Disability Access Report

**Proposed Shop-top
Housing Development**

71-75 Victoria Avenue
DRUMMOYNE NSW

For: Olter Investments Pty Ltd
Ref: LP_20211

Figure 2 | Overall Site Plan

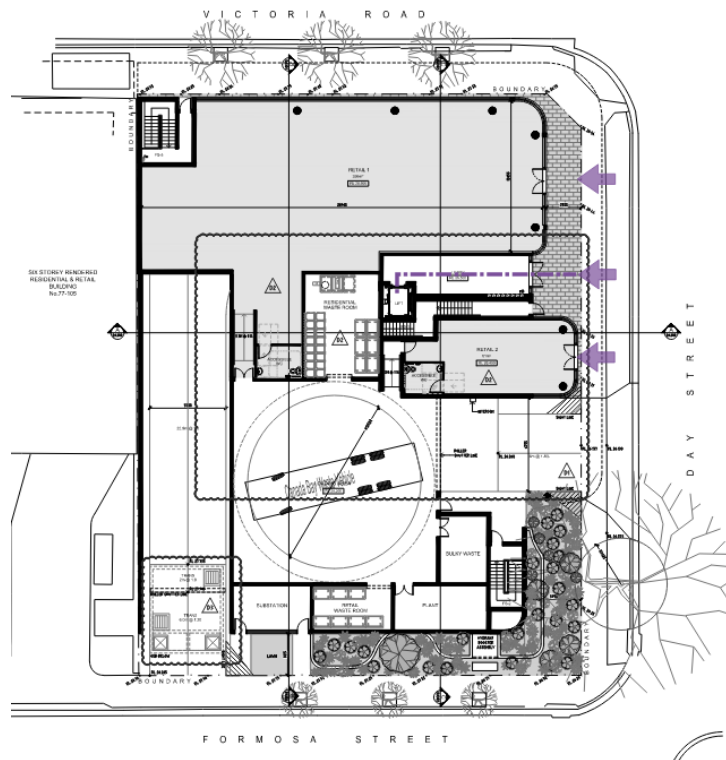
- from the allotment boundary at the pedestrian entrance along Day Street to the Retail and Residential entrances
- from the accessible carparking areas to the building entrance.

On-grade access is available from Day Street to the retail and residential entrances.

A lift provides access to all levels of the building including basement car parking. On-grade access is available from the accessible car parking to the lift at each basement level.
